SEWAGE DISPOSAL SYSTEM

DEPARTMENT OF HEALTH AND MENTAL HYGIENE

SUBDIVISION Gleneig Manor Estates LOT 18B ROAD 12763 Folly Quarter Road

DESIGNED JME	SITE DEVELOPMENT PLAN LOT: 18A-B GLENELG ESTATES SECTION TWO 5TH ELECTION DISTRICT HOWARD COUNTY, MARYLAND	SCALE 1" = 50'	
DRAWN BAK		DRAWING 1 OF 1	
CHECKED JME		JOB NO. 90-071	
DATE April 1991		FOR: MR. JAXON TAYLOR 1908 Forest Dale Drive Silver Spring, Md. 20903	FILE NO. 90-071-X

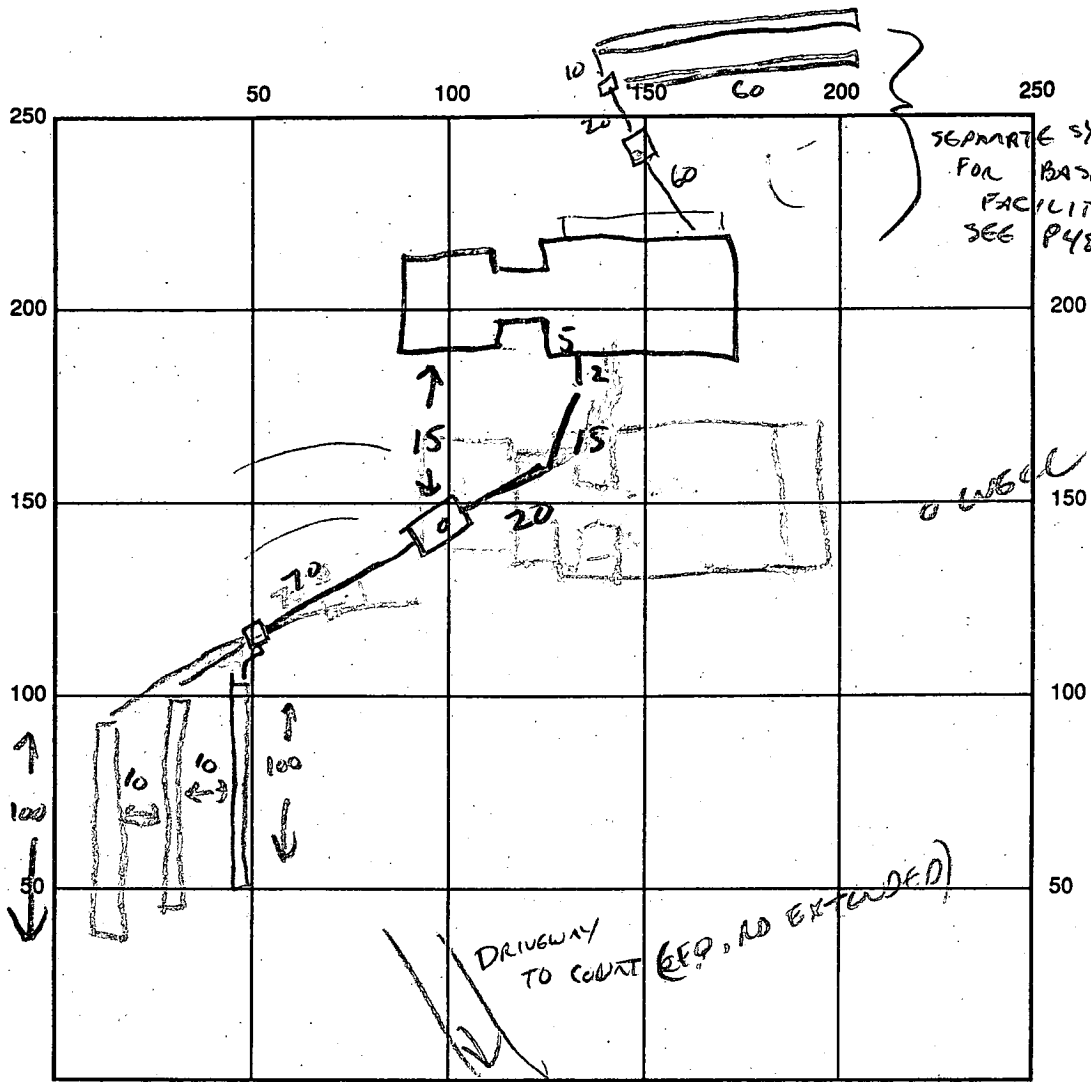
TRENCHES - Trench to be 3 feet wide. Inlet 3 feet below original grade. Bottom maximum depth 5 feet below original grade. Effective area begins at 3 feet below original grade. 2 feet of stone below distribution pipe.

LOCATION - Place distribution box 10 feet from the North (301') lot line and 45 feet from West (154') lot line. Run trenches on contour within the revised sewage disposal easement.

NOTES - No trench to exceed 100 feet in length. Provide 6" - 8" diameter cleanout and cap to grade or above on septic tank.

REMARKS: 12/24/93 SYSTEM COMPLETE. OK TO COVER, CV

P 48478

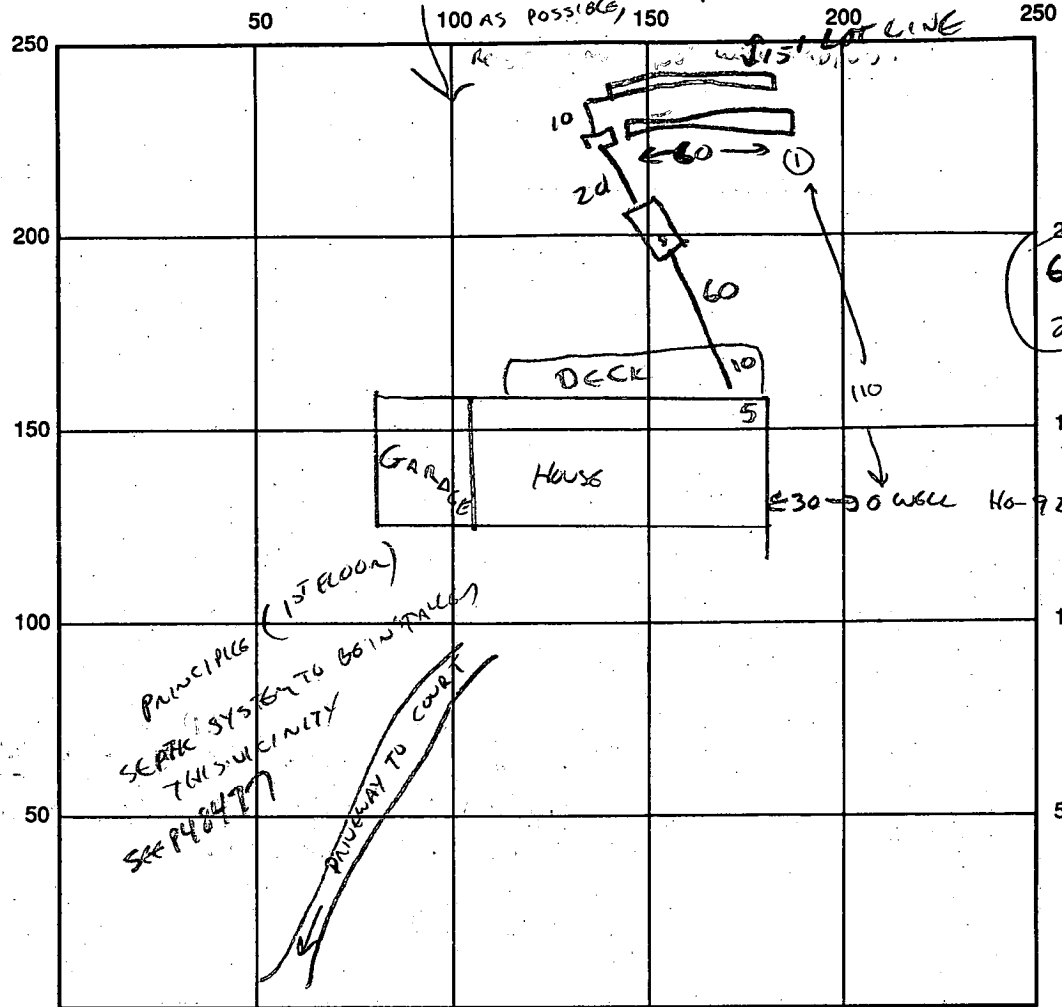
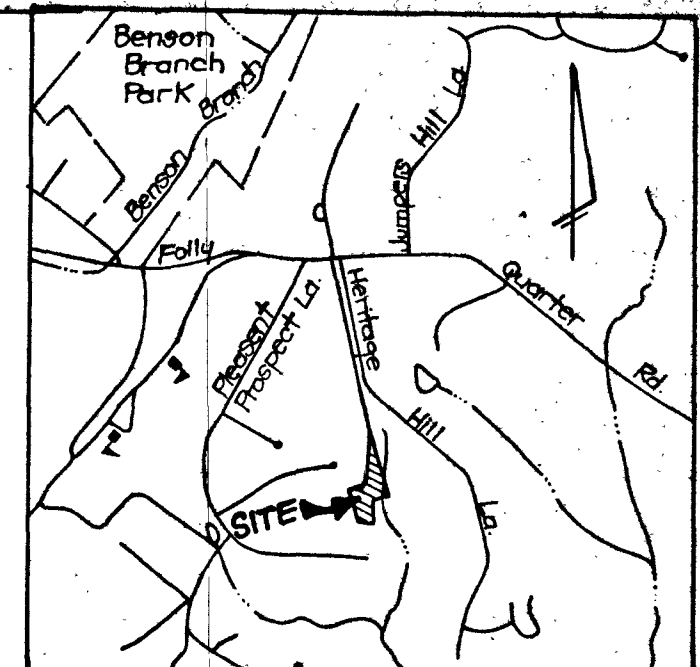
REPAIR PERMIT ISSUED TO
AUTHORIZE INSTALLATION OF A NEW
SEPARATE SYSTEM TO SERVE
BASEMENT FACILITIES ONLY.

REPAIR - PURPOSE - TO DETERMINE ADEQUATE SOIL CONDITIONS TO INSTALL SEPARATE SEPTIC SYSTEM FOR BASEMENT (1 Test Hole Required) 9/04/92

SOILS WET AT 9 1/2'; 6-7 MINUTE PERC AT 2 1/2'

OK TO INSTALL 1000' GAL TANK, \approx 100' LINEAR FT OF TRENCH,

3' WIDE; INLET 1'; MAX BOTTOM DEPTH 2 1/2'; 1 1/2" STONE BELOW DISTRIBUTION PIPE.

PLACE DISTRIBUTION BOX TO REAR OF HOUSE EXACTLY 100' FROM WATER WELL. RUN TRENCHES ALONG CONTOUR ROUGHLY PARALLEL TO HOUSE. OK TO INSTALL SEPTIC TANK 80' FROM WELL.

SECONDARY SEPTIC SYSTEM (BASEMENT FACILITIES ONLY)
 TO BE INSTALLED AS CLOSE TO HOUSE
 100 AS POSSIBLE, 150

PRINCIPLES
 SEPTIC SYSTEM TO BE INSTALLED
 THIS VICINITY
 SEE P48477
 DRIVEWAY TO COURT
 (1ST FLOOR)

REMARKS: SYSTEM COMPLETE OK TO COVER, SERVES BASEMENT ONLY, 12/24/92 CW
SEE OTHER PAGE FOR FIRST FLOOR SYSTEM DETAIL.
